Interactive comment on “Balancing energy and environmental concerns: the case of the Kayraktepe dam, Turkey” by Ö. Sever et al.

Received and published: 16 January 2013

Fig. 1. Figure 1b

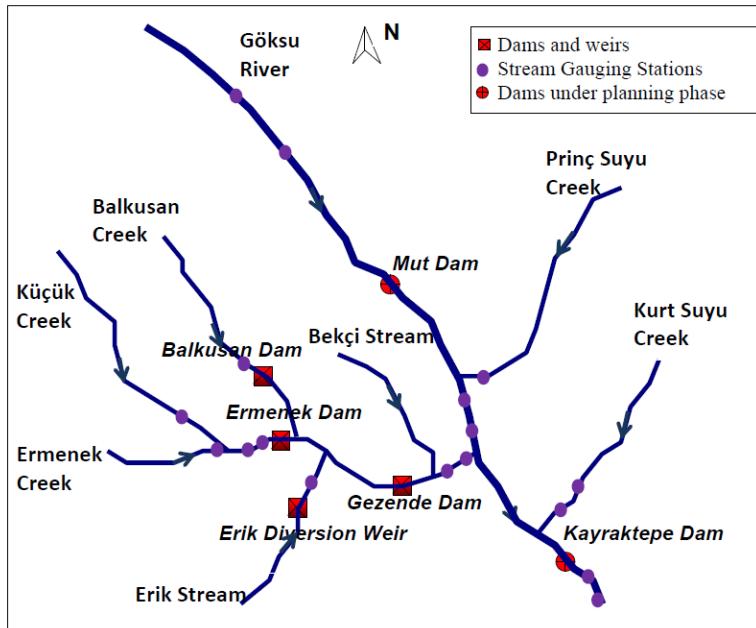
11775-14 In the same vein as the comment above, the Mut Dam is introduced to the discussion with no preparation, as though the reader is already informed about its background and role in the system. This makes it very difficult to interpret the flood control functions of the dams. 11776-7 Again the Mut Dam is introduced to play a major role in the flood routing of the Kayraktepe Dam reducing the flood volume dramatically, but with no indication of how this was achieved. Because of this the description of the performance of all the dams in this system is not systematic and is difficult to interpret.

The figure 1 re-drawn to clear out the confusion.
